METROPOLITAN GOVERNMENT OF NASHVILLE AND DAVIDSON COUNTY

STAFF RECOMMENDATION 517 Wilson Boulevard North November 19, 2014

Application: New construction-outbuilding
District: Richland-West End Neighborhood Conservation Zoning Overlay
Council District: 24
Map and Parcel Number: 10308016900
Applicant: Emily Dyer
Project Lead: Paul Hoffman, paul.hoffman@nashville.gov

Description of Project: The application is for new construction of a one-and-a-half story outbuilding behind the historic house. The outbuilding will have a footprint of seven hundred and eighty square feet (780 sq. ft.).

Figure 1. 517 Wilson Blvd North

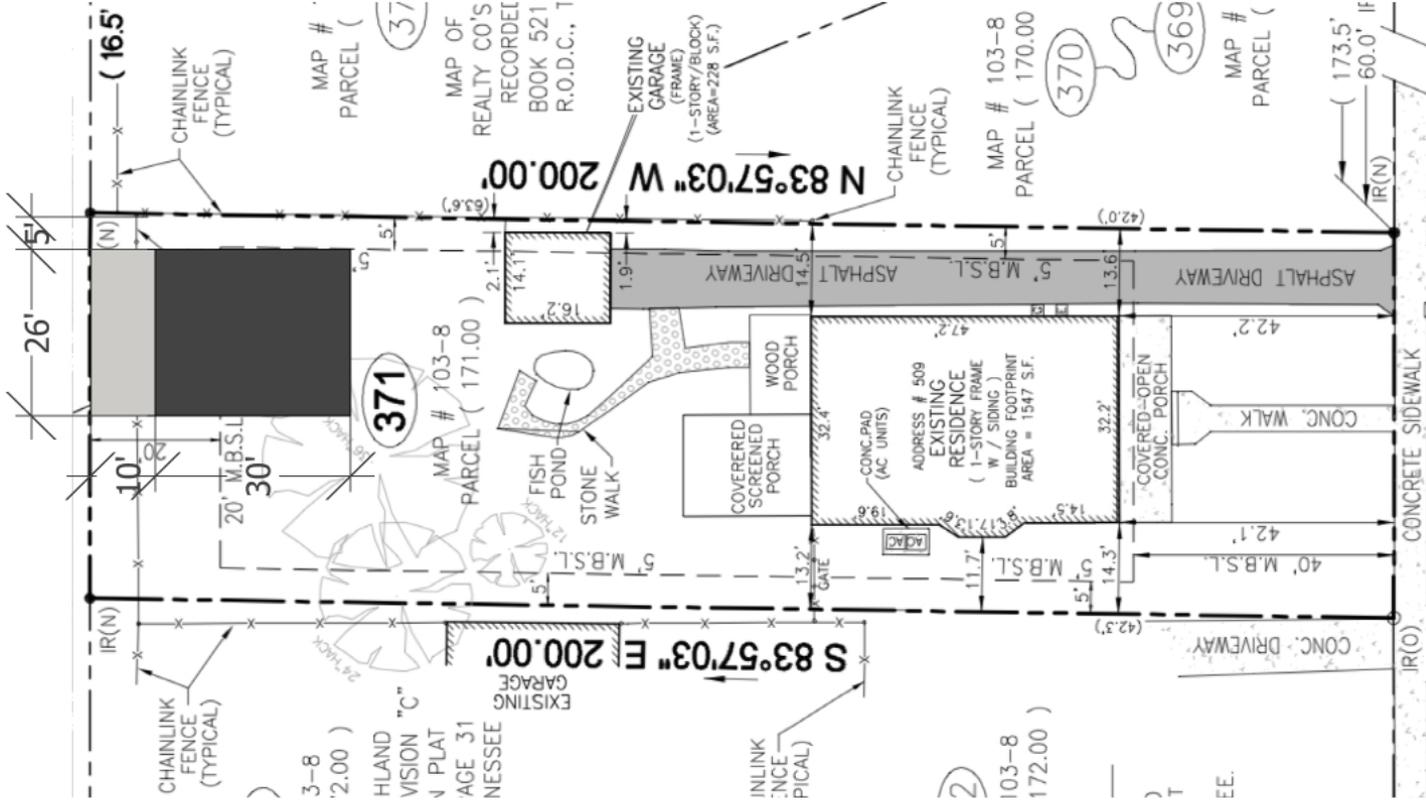
Roof: The proposed roof is a gable with approximately 6/12 pitch. It is compatible with the primary building. A shed dormer on the south side matches the existing dormer on the house. The dormer takes up approximately thirty-eight percent (38%) of the roof plane, and sits directly over the wall beneath; Staff requests the dormer sit back from the wall by at least two feet (2') to comply with the design guidelines. With this condition, the project meets section II.B.h.1.

1. The eave height of the outbuilding be reduced to ten feet (10') or less;
2. The dormer be moved back to sit two feet (2') from the exterior wall;
3. Lap siding have no more than five inches (5") reveal; and
4. Staff approve the final details, dimensions and materials of windows, doors and garage doors prior to purchase and installation.
